U. S. Nuclear Regulatory Commission
ATTN: Document Control Desk
Washington, D. C. 20555-0001Southern Nuclear Operating Company
Joseph M. Farley Nuclear Plant - Units 1 and 2
Edwin I. Hatch Nuclear Plant - Units 1 and 2
Vogtle Electric Generating Plant - Units 1 and 2
Vogtle Electric Generating Plant - Units 3 and 4

License Amendment Request to Revise the Emergency Plan to Change Staffing and
Extend Staff Augmentation Times for Emergency Response Organization Positions

**License Amendment Request to Revise Standard Emergency Plan
To Change Staffing and Extend Augmentation Times**

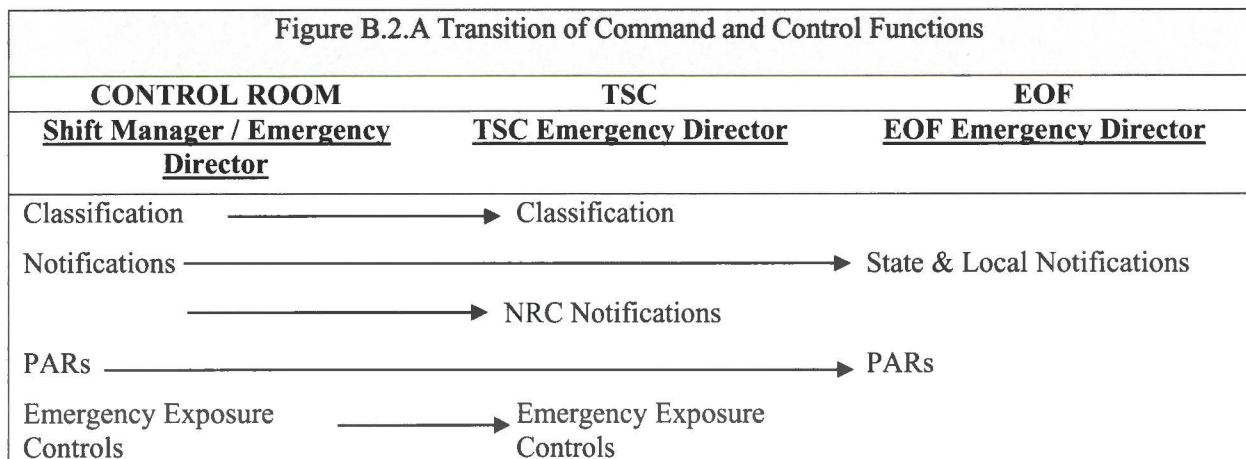
- d. Section B.2, "On Site Emergency Response Organization", revised Figure B.2.A to better reflect transfer of offsite notification functions.
- e. Section B.2.1.10, "TSC Chemistry Support", removed reference to Chemistry staffing for sampling purposes.

Figure B.2.1.A – Technical Support Center Organization

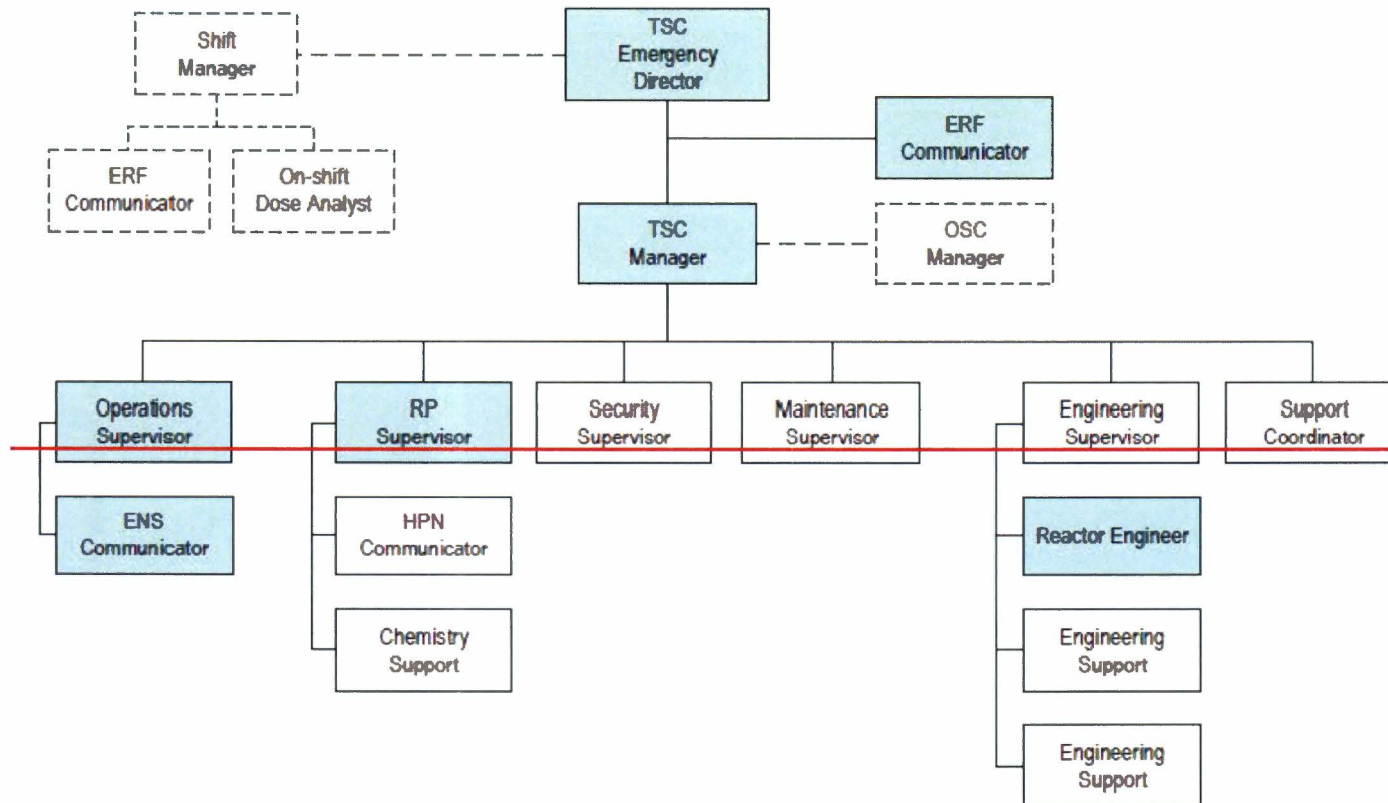
- k. Section B, Table 4, "JIC Staff", removed as the information duplicates the facility staffing as noted in Figure B.3.2.A.
- l. Section B, Figure B.2.1.A, "Technical Support Center Organization", revised to reflect minimum staff positions associated with command and control functions and required for facility activation.

Figure B.2.2.A – Operations Support Center Organization

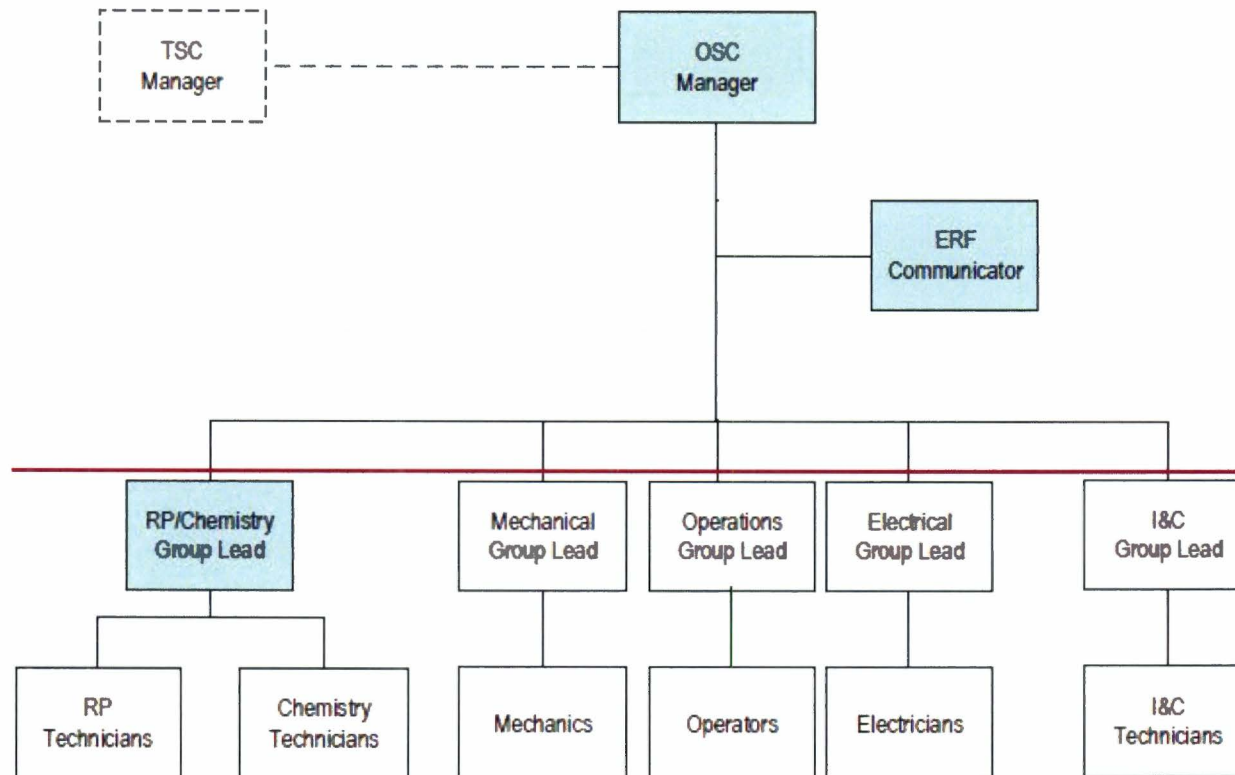
- m. Section B, Figure B.2.2.A, "Operations Support Center Organization", revised to reflect minimum staff positions associated with command and control functions and required for facility activation, and removed the reference to Administrative Support Staff.

Figure B.3.1.A – Emergency Operations Facility Organization

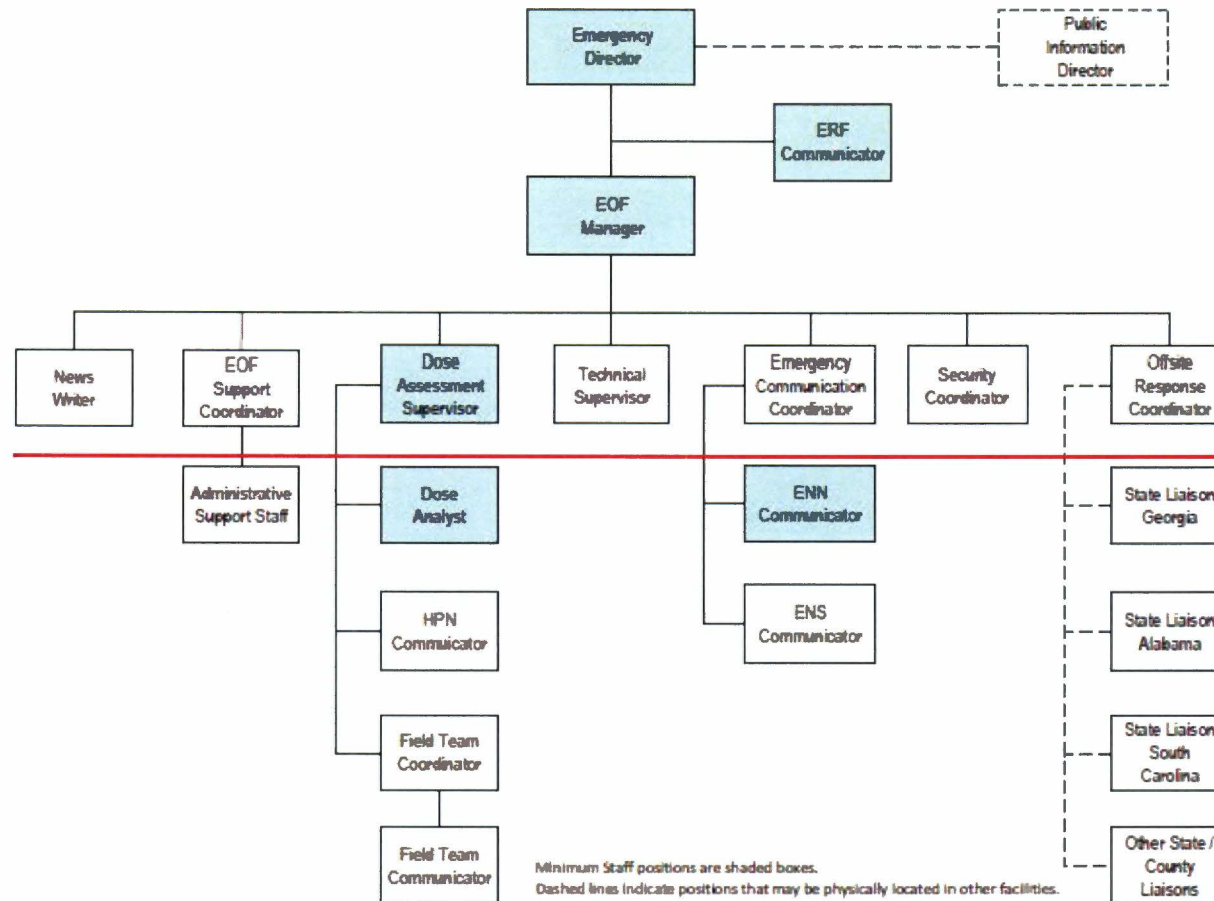
- n. Section B, Figure B.3.1.A, "Emergency Operations Facility Organization", revised to reflect minimum staff positions associated with command and control functions and required for facility activation.

Figure B.3.2.A – Joint Information Center Organization

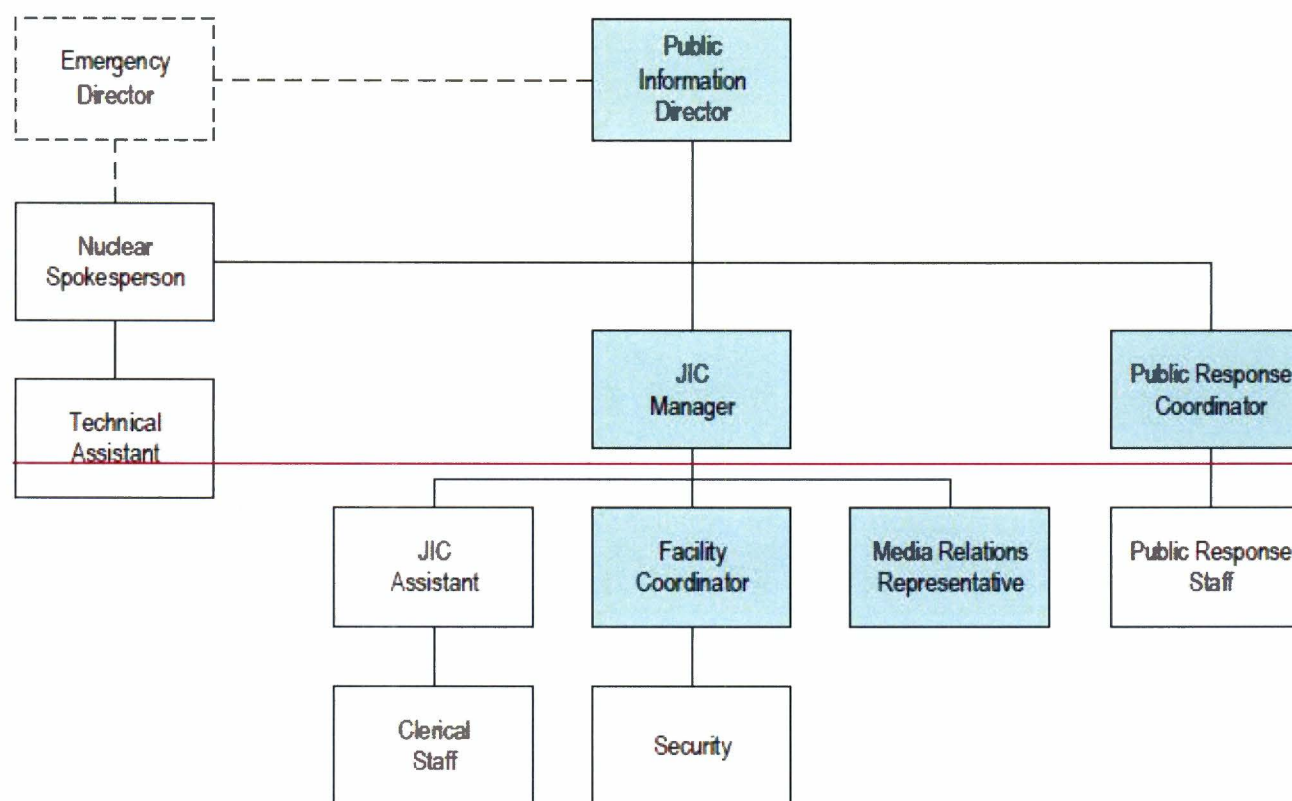
- o. Section B, Figure B.3.2.A, "Joint Information Center Organization", revised to remove references to minimum staff positions and extend facility staffing to 90 minutes.
